City of Sandy

Planning Commission Meeting

- 7.1. 21-021 SUB/VAR/TREE/HD The Bornstedt Views Subdivision 12 - 970
[21-021 SUB VAR TREE HD The Bornstedt Views Subdivision - Pdf \(1\)](#)
[Exhibit A - Land Use Application - The Bornstedt Views](#)
[Exhibit B - Narrative - Supplemental Narrative - The Bornstedt Views](#)
[Exhibit C - Civil Plans - The Bornstedt Views](#)
[Exhibit D - Storm Drainage Report - Bornstedt Views](#)
[Exhibit E - Traffic Impact Study - Bornstedt Views -Final and Stamped \(May 23, 2022\)](#)
[Exhibit F - Arborist Report - Updated - Bornstedt Views \(April 29, 2022\)](#)
[Exhibit G - Stream and Wetland Determination - Updated - Bornstedt Views \(April 29, 2022\)](#)
[Exhibit H - Geotech Report - Updated - Bornstedt Views \(April 29, 2022\)](#)
[Exhibit I - Geotech Supp Review Letter- Updated - Bornstedt Views \(April 29, 2022\)](#)
[Exhibit J - Survey Map - SN2022-026](#)
[Exhibit K - Email from City Engineer - Bornstedt Views \(April 29, 2022\)](#)

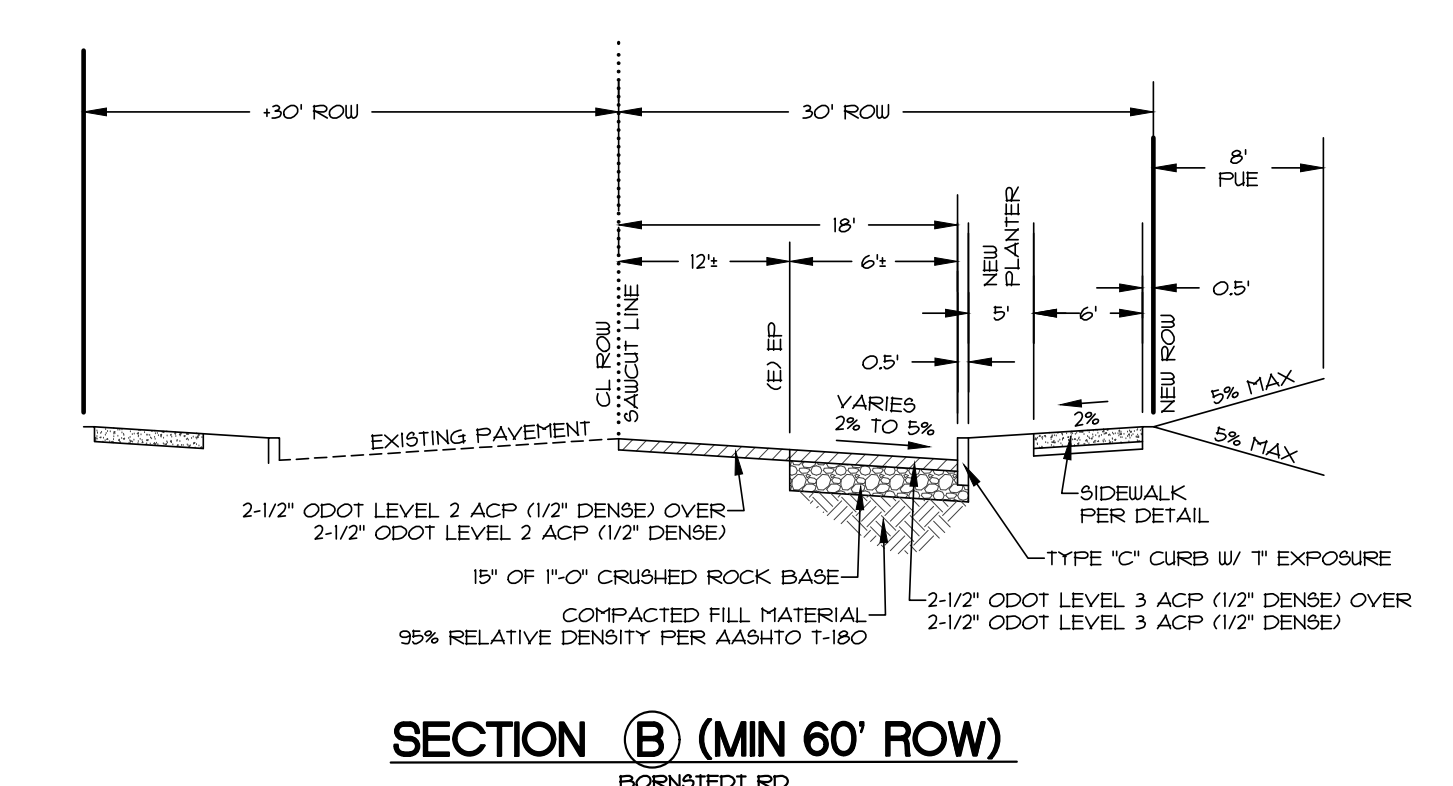
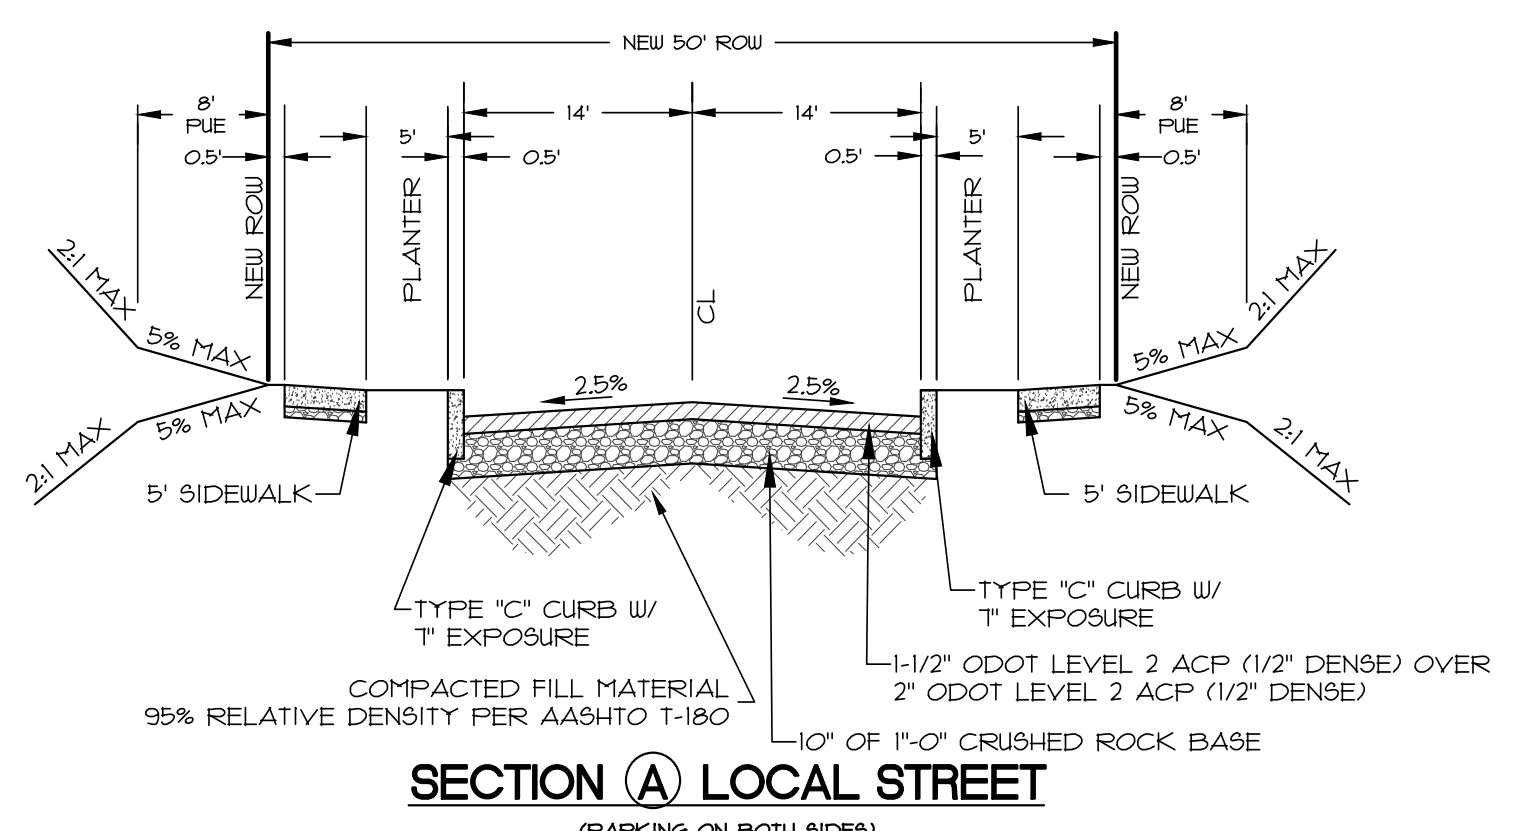
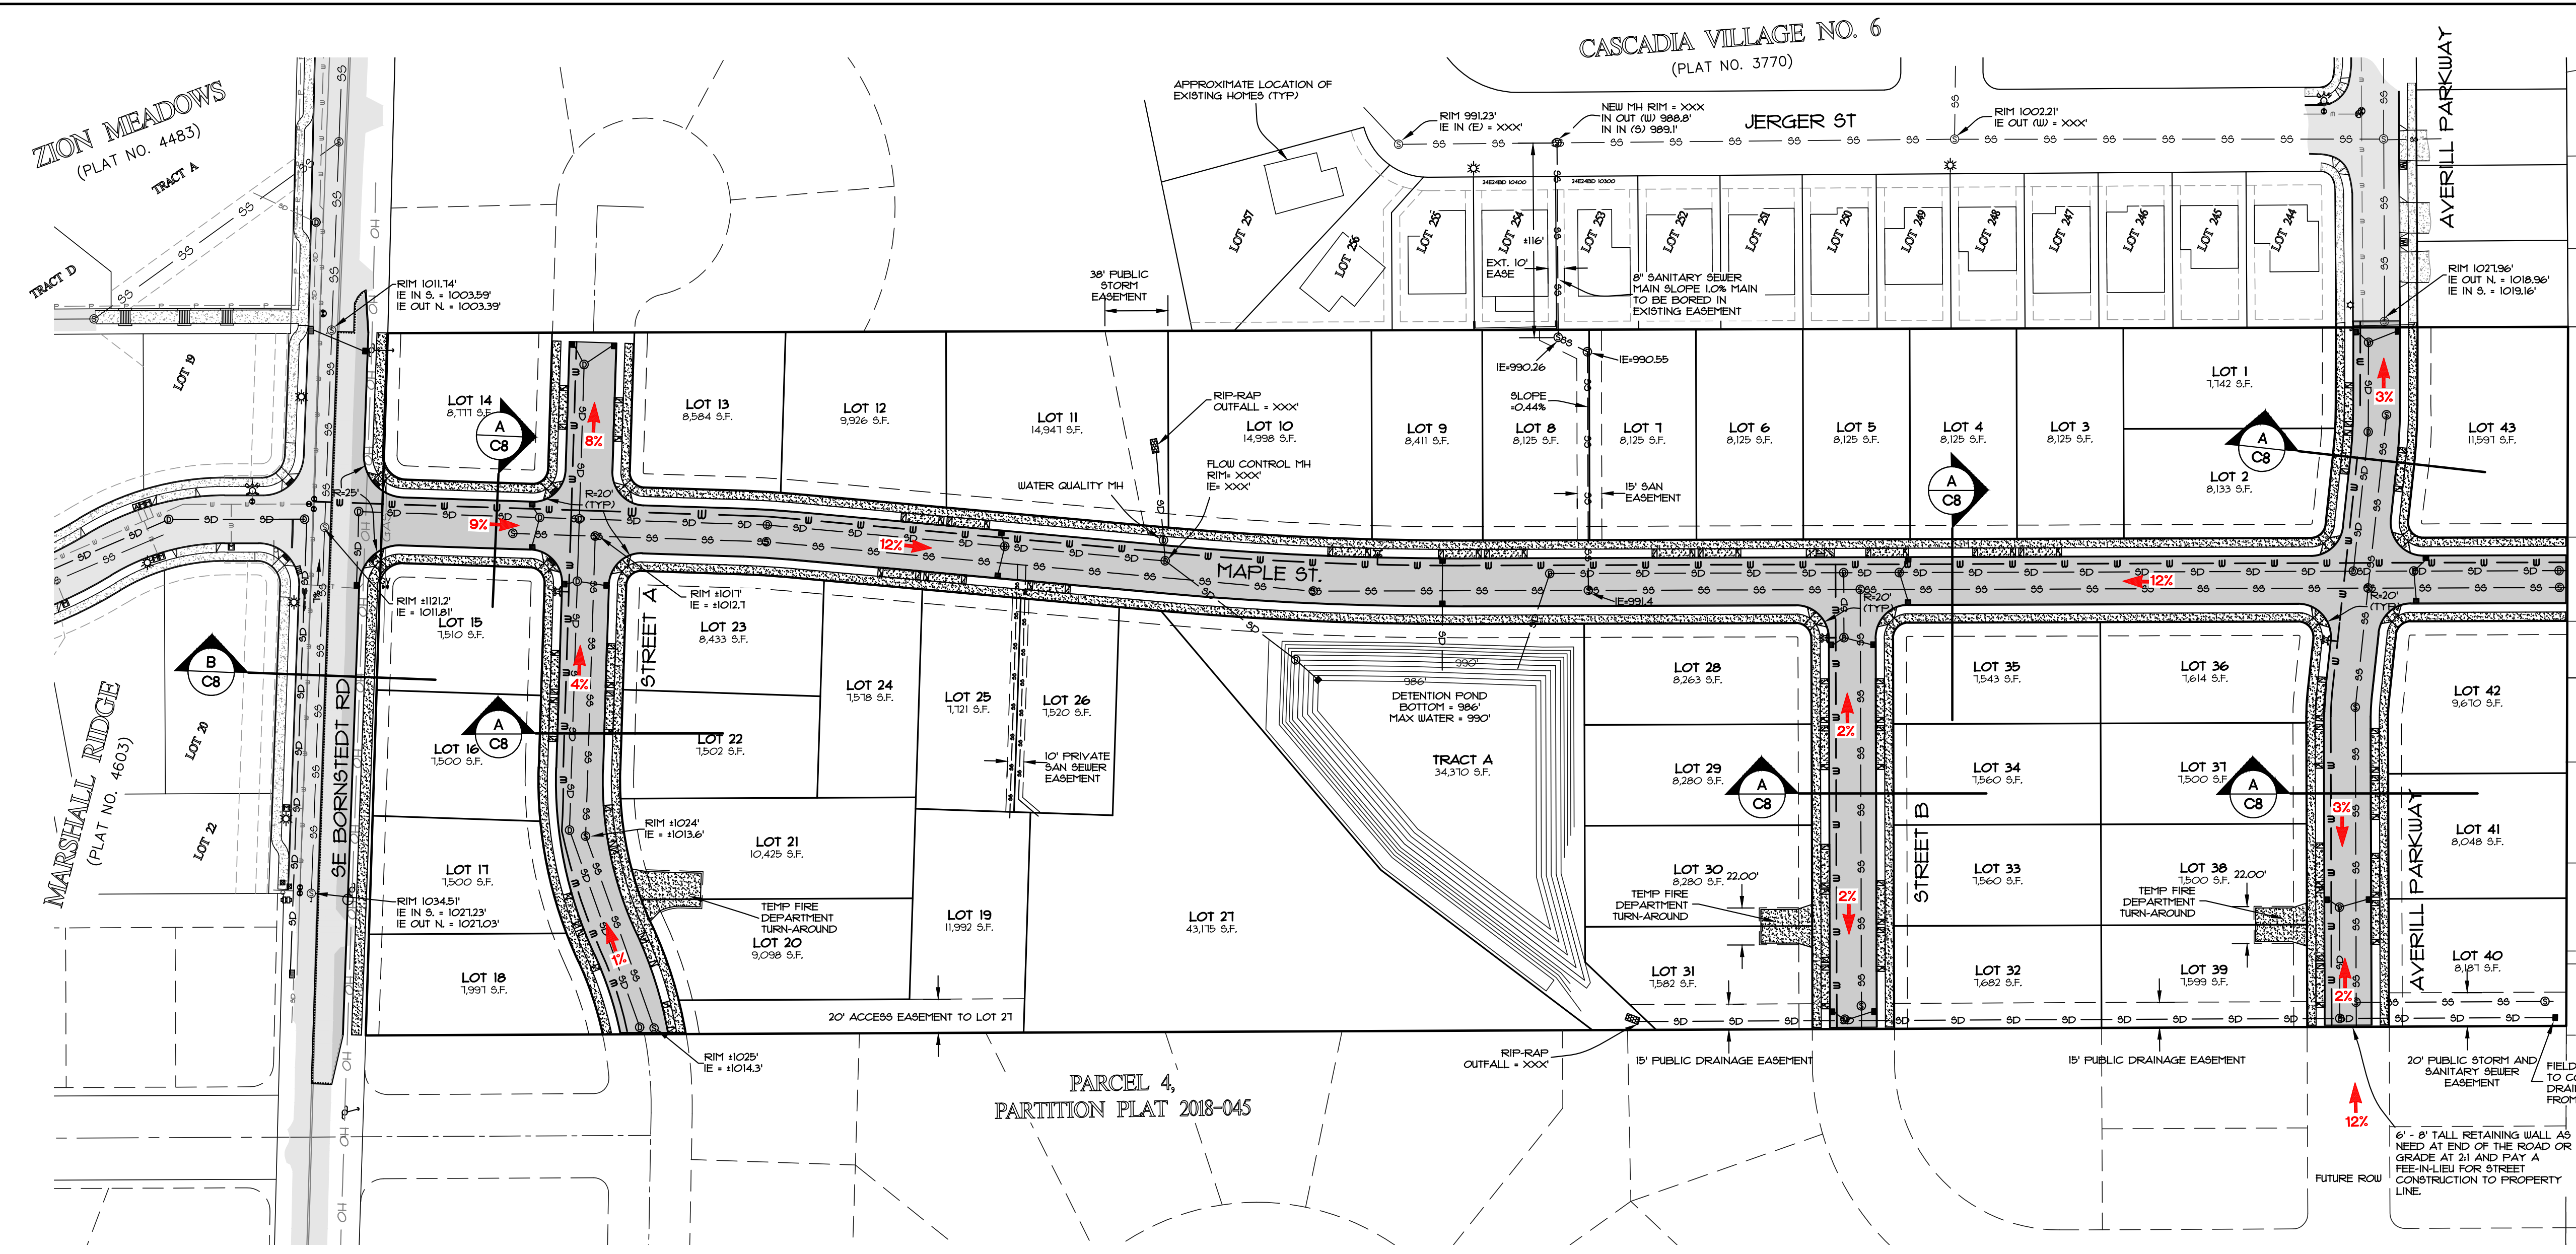
67. Sections 17.84.50(F and G) require public streets to be improved to City standards along the entire frontage of the property. The Street and Utility Plan (Exhibit C, Sheet C8) details street improvements extending to the property boundary on all streets with the exception of the north end of Street A. The street improvements proposed adjacent to Lots 13 and 14 do not extend to the edge of the adjacent property to the north as required in Sections 17.84.50(F.1) and 17.84.50(G). **The applicant shall update the Street and Utility Plan to detail street improvements on the frontages of Lots 13 and 14 that extend to the property line per Sections 17.84.50(F.1) and 17.84.50(G). Retaining walls in the right-of-way or slope easements on adjacent parcels may be required to accomplish this. The frontage improvements for Tract A (and any additional tracts) shall be completed prior to final plat approval.**

78. Section 17.84.60 outlines the requirements of public facility extensions. The applicant submitted a Street and Utility Plan (Exhibit C, Sheet C8) which shows the location of proposed public water, sanitary sewer, and stormwater drainage facilities. The City Engineer reviewed the proposal and provided comments (Exhibit U). **All public infrastructure improvements shall comply with the City of Sandy standards and Public Works requirements. A more thorough review shall be required once the construction plans and details are provided.**

85. The Fire Marshal (Exhibit N) reviewed the proposal and expressed one concern. The Street and Utility Plan (Exhibit C, Sheet C8) details a 12 percent grade along Maple Street east of Street A. Per the Oregon Fire Code, access roadway grades shall not exceed 10 percent.

PROJECT: **THE BORNSTEDT VIEWS GRADING AND EROSION CONTROL PLAN**

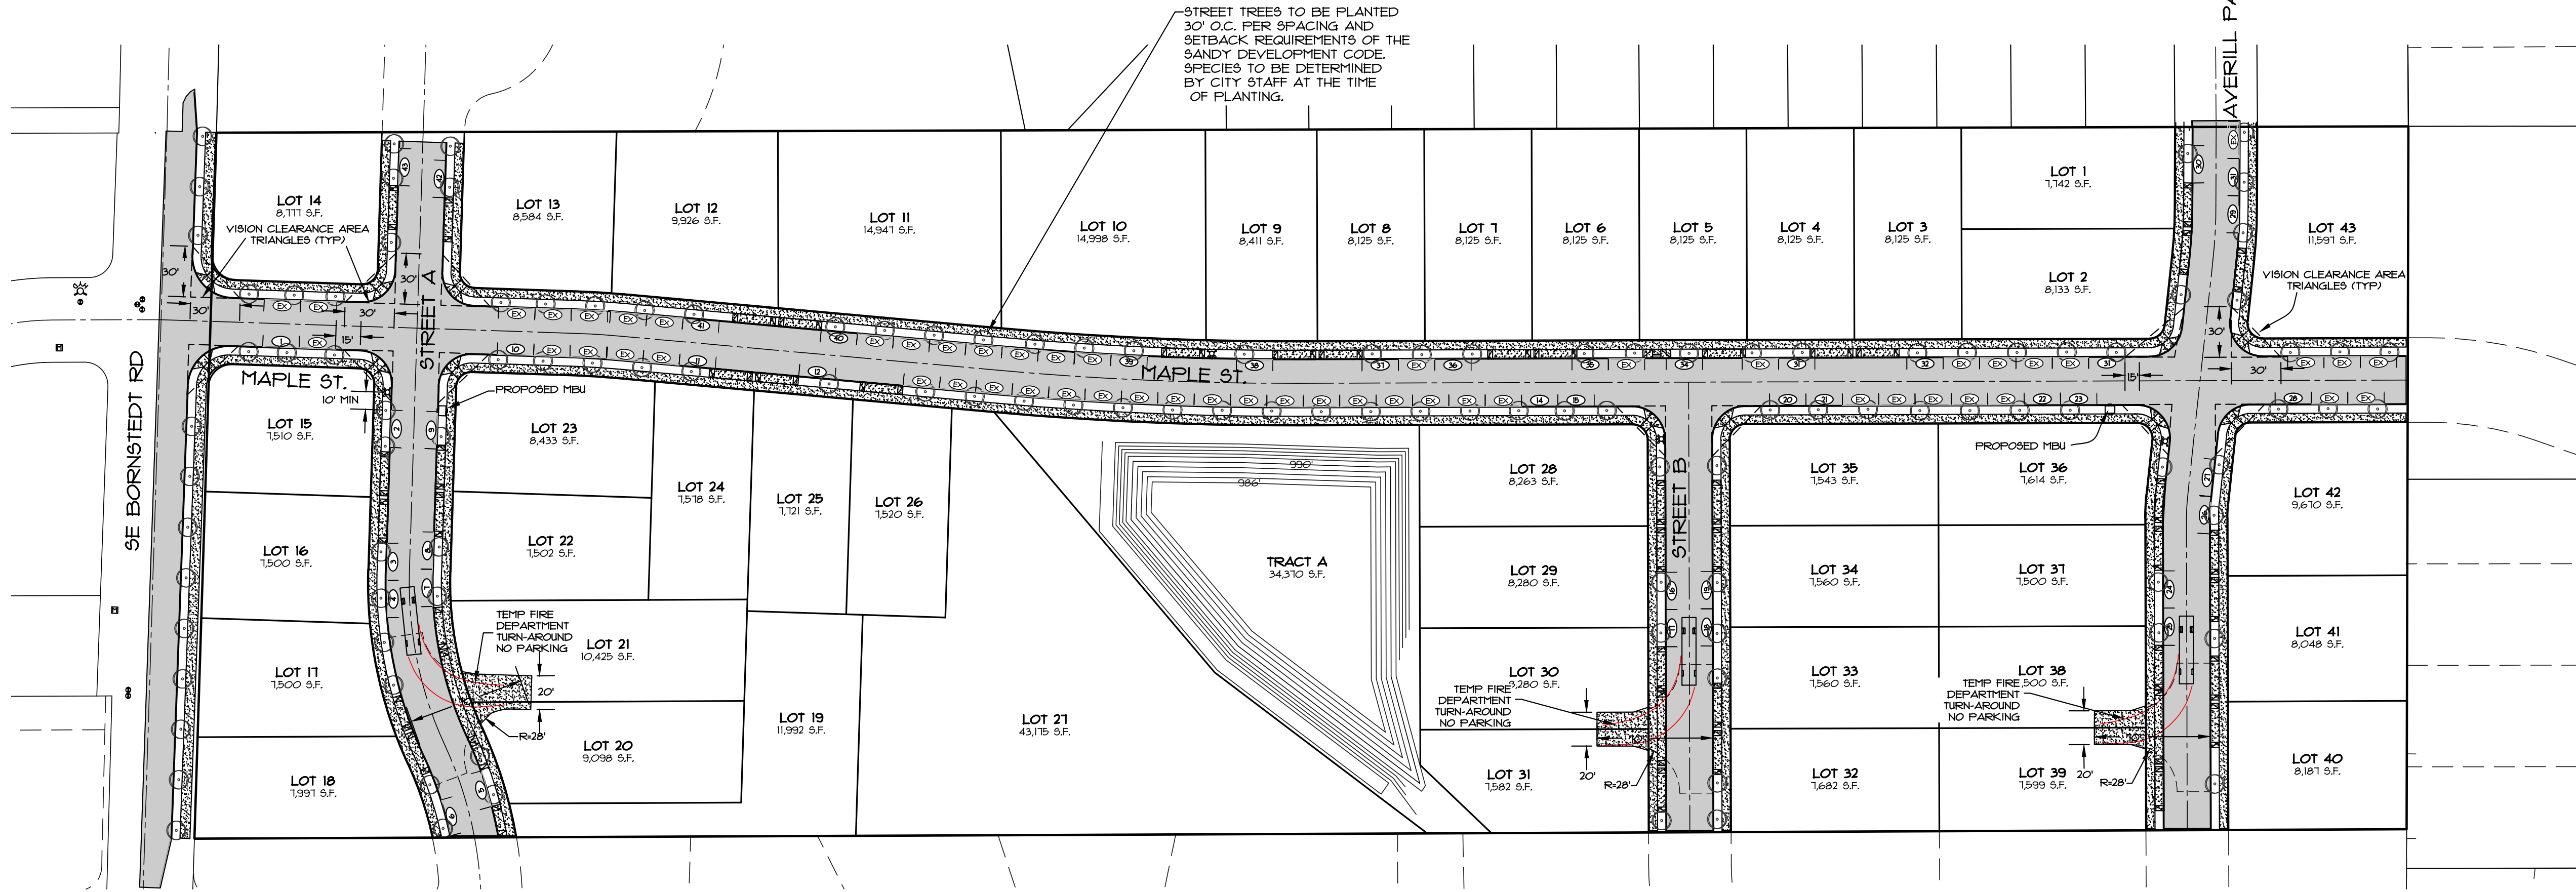
116. During review of the geotechnical report and civil plan set, the third-party reviewer noticed that Lots 20, 21, 24, and the flagpole driveway for Lots 19 and 27 are planned in the middle of an existing drainage. The Grading and Erosion Control Plan (Exhibit C, Sheet C9) does not detail any proposed changes in grade on Lots 19, 20, 21, 24, or 27. As currently detailed on the Grading Plan, it's quite possible that water will flow onto these lots towards the houses and Maple Street. **To prevent seasonal surface water runoff from flowing**

117. Grass seeding shall be completed as required by Section 17.100.300. The submitted Grading and Erosion Control Plan (Exhibit C, Sheet C9) provides additional details to address erosion control concerns. A separate Grading and Erosion Control Permit will be required prior to any site grading. Erosion control requirements are defined in greater detail in Chapter 15.44 of this document. Section 15.44.50 contains requirements for maintenance of a site including re-vegetation of all graded areas. **The applicant's Erosion Control Plan shall be designed in accordance with the standards of Section 15.44.50.**
